# Mark III LOCA-Related Hydrodynamic Load Definition

Generic Technical Activity B-10  
Final Report

Office of Nuclear Reactor Regulation

Figure 3-9 Froth Impact Measurements (from Figure 3-8)  
 Scaled up to Full Size Using "Modified Froude Scaling";  
 Also Shown: NRC Acceptance Criteria

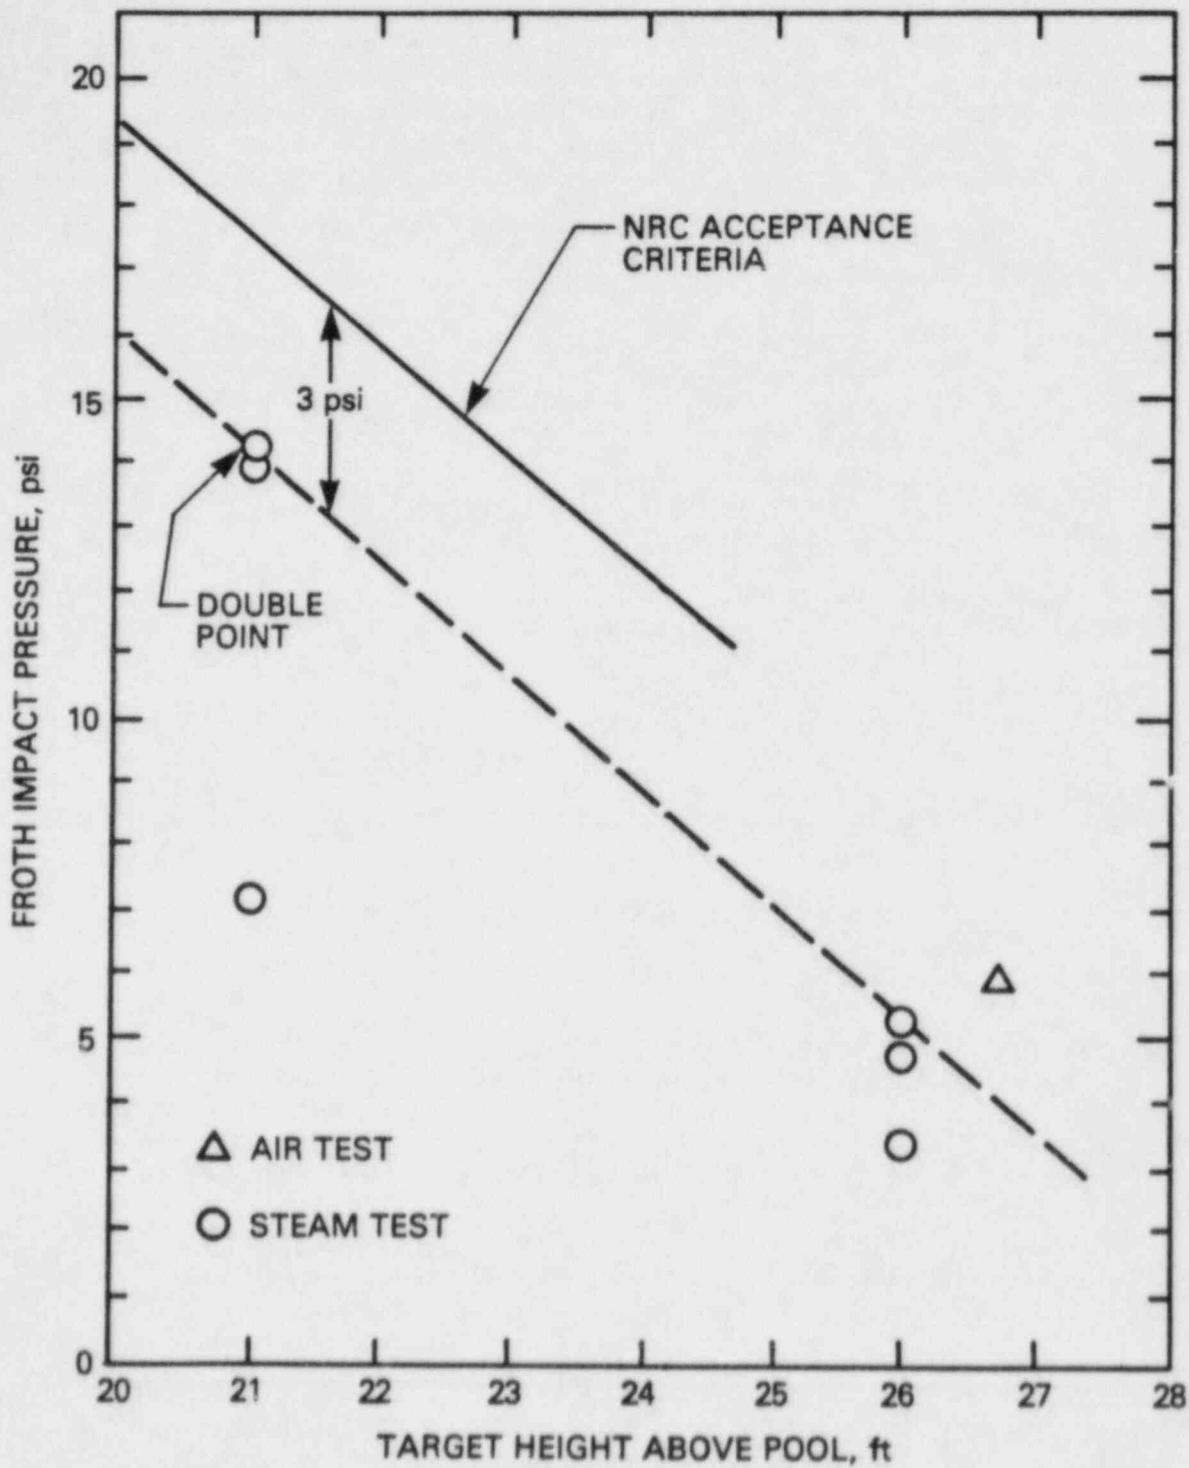
To arrive at an acceptance criteria for froth impact, it must be acknowledged that there are some uncertainties associated with the results in Figure 3-9. First, the model is not perfectly scaled geometrically. For example, the vent lengths, as well as the spacing between the vents in the PSTF facility, are full-scale rather than 1:1.5. The "Modified Froude Scaling" itself is an approximation containing conservative as well as nonconservative elements (see Section 3.2.1). The linear variation of froth impact pressure in Figure 3-9 is clearly an approximation of a more complex behavior. Froth impact itself is somewhat random and only approximately repeatable. To cover all these uncertainties, a margin of 3 psi was judged to be appropriate in arriving at the staff acceptance criteria. Its application is illustrated in Figure 3-9.

Since froth impact is only slightly affected by the geometry of the structure, the same acceptance criteria that the staff has developed for froth on small structures between the pool and the HCU floor (see Figure 3-9) shall be used for expansive structures at the HCU floor elevation.

The NRC Acceptance Criteria stipulates that the same froth impact pressure (vs. elevation) used for small structures between the pool and the HCU floor (Figure 3-9) be also used for small structures at and above the HCU floor elevation. For flat structures higher than 26 feet and pipes higher than 28.5 feet above the initial pool surface the GESSAR-II specification is acceptable.

Figure 3-10 Comparison of NRC Acceptance Criteria with GESSAR-II for Froth Impact at and Above the HCU Floor

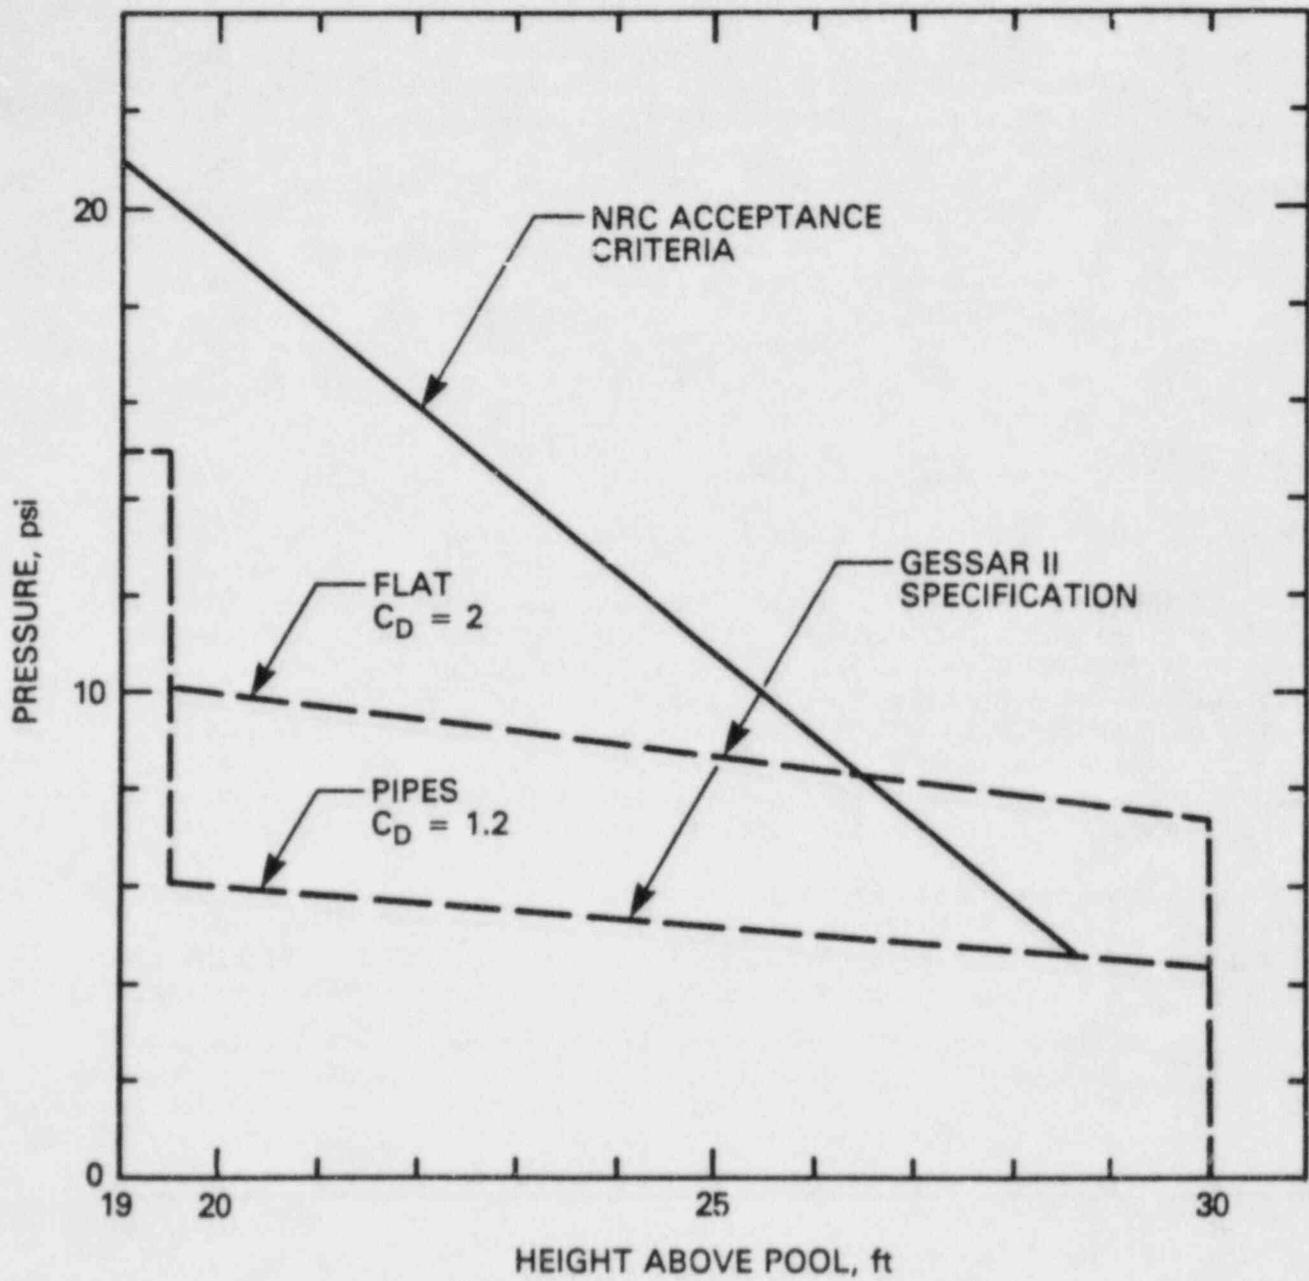
(When one deals with froth, there is really no distinction between impact and drag. In both cases the load is caused by momentum transfer of individual particles of water as they impinge on the structure.) The main difficulty, however, is that the GESSAR-II specification underpredicts pressures when compared to values determined from test data in conjunction with the "Modified Froude-Scaled" Analysis. The comparison of the GESSAR-II specification with what the staff believes to be a realistic assessment of froth impact pressures is shown in Figure 3-10.

For structures above grated areas of the HCU floor, the pressures shown in Figure 3-10 may be multiplied by the ratio of grating open area to grating total area.

Figure C-3 NRC Acceptance Criteria for Froth Impact: Peak Amplitude of Pressure Pulse

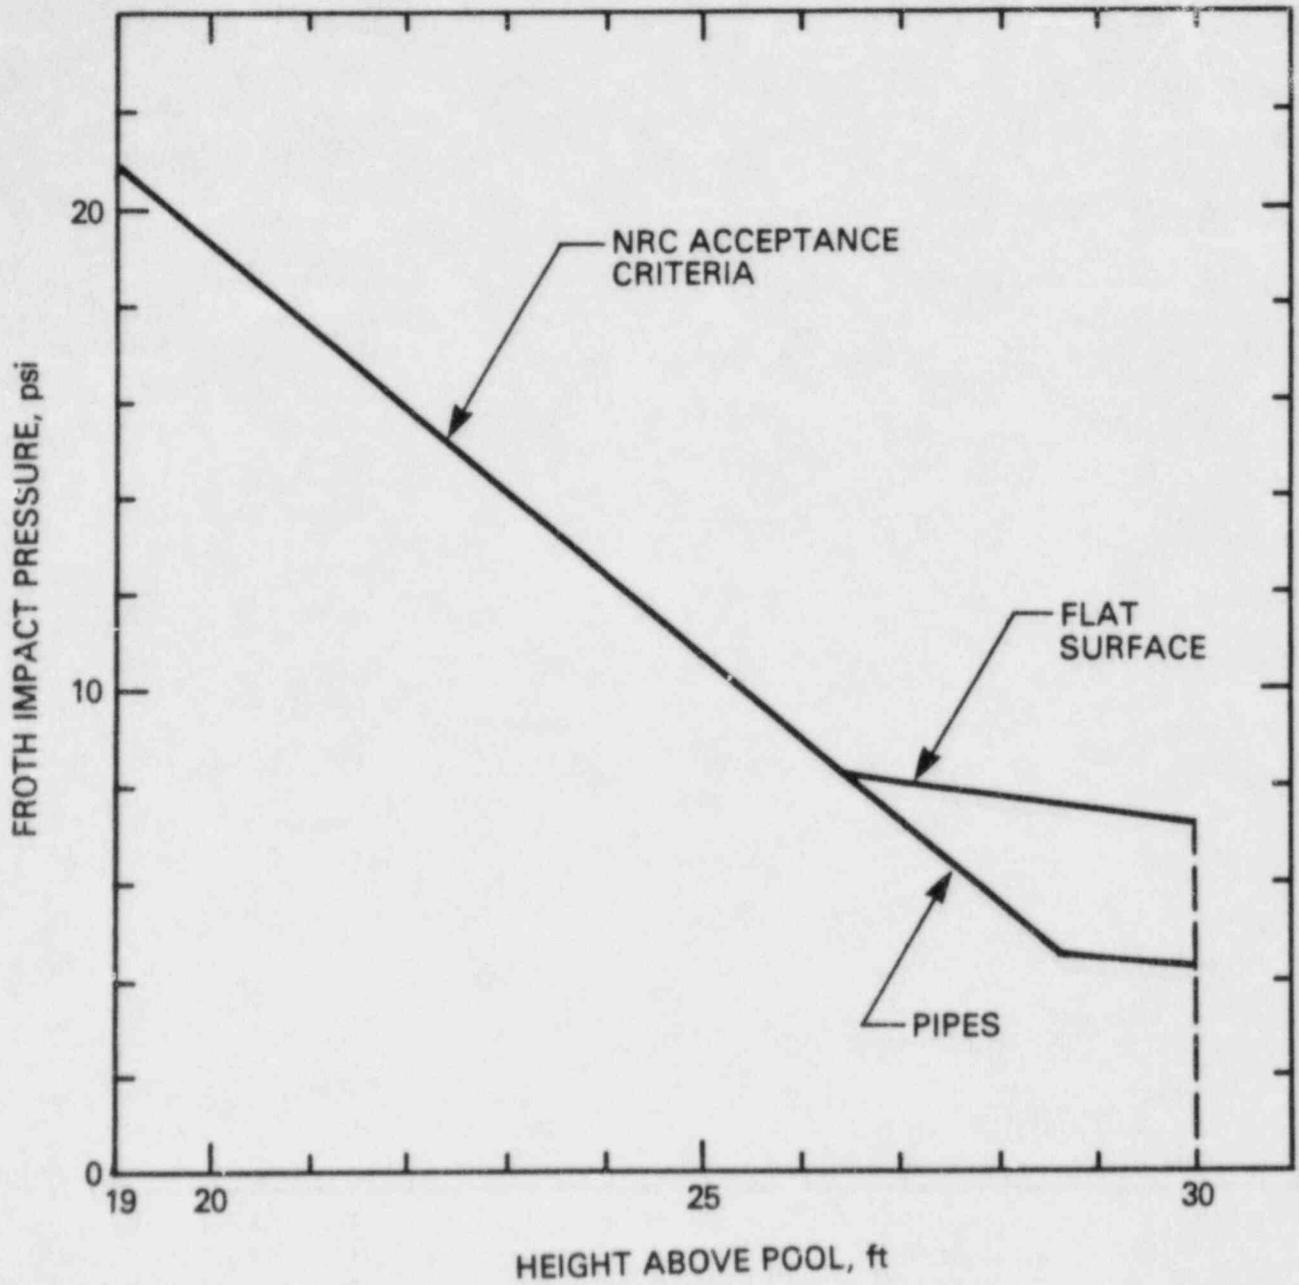
The forcing function for froth impact shall be an isosceles triangle with a maximum pressure amplitude given in Figure C-3. The pulse duration shall be chosen such as to give a maximum DLF with a triangular pulse. For elongated structures that span the annulus of the wetwell, pulse durations shorter than 50 msec need not be considered.

For structures above grating areas at the HCU floor the pressures from Figure C-3 may be multiplied by the ratio of grating open area to grating total area.
